SERVICE BULLETIN

AP-SB16

Date of Issue: July 2012

SUBJECT: UPGRADE OF AP332 FERRULE COMPONENT WHEN USED ON JABIRU ENGINES

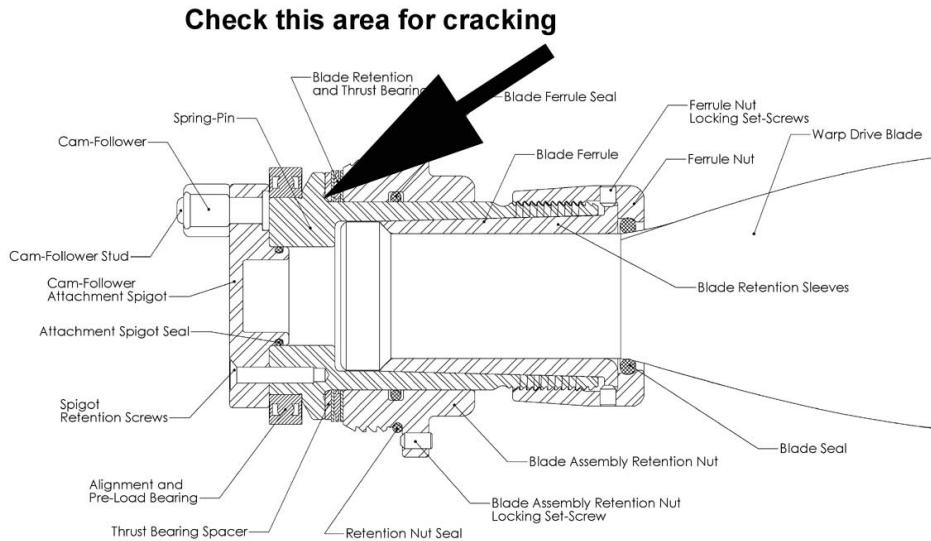
Airmaster has received reports of cracks appearing in the ferrule component of models AP332 when used on Jabiru engines. The cracks have been located at the base of the ferrule component, in the area where the ferrule body flares to the flange.

Airmaster have revised the ferrule component (AP-P0074b), and changed its material to increase its fatigue life. The revised ferrule type can be identified by a dot placed on the perimeter of the ferrule flange.

1. An inspection of the blade ferrule should be made immediately.

- a. Inspect the blade ferrule for cracking or corrosion. Pay particular attention to the fillet area between the flange at the inner end of the ferrule and the main cylindrical section of the ferrule, as this is the principal load bearing area. Inspect this area closely under good illumination.

Note: This area of the ferrule may be seen by sliding the blade assembly retention nut, the blade retention and thrust bearing, and the aluminium spacer towards the outboard end of the ferrule. After wiping away excess grease, the fillet area to be inspected will be exposed. A matt finish will be observed on the area, where the surface has received a shot peen treatment to enhance its fatigue properties.

2. If a crack is detected (or suspected), all three blade assemblies should be returned to Airmaster for ferrule replacement. There is no charge for this service (shipping charges still apply).
3. If no cracks are found, then this information should be relayed to Airmaster propellers, along with the following,

4. Airmaster advises that even if no cracks are detected during inspection, it is still recommended to apply the ferrule upgrade at the soonest possible time.

5. If the ferrule is replaced, inspection of the ferrule as outlined above should be carried out at intervals 25hr, 50hr, 100hrs there after.

6. If ferrule has not been replaced inspection should be every 25hrs.
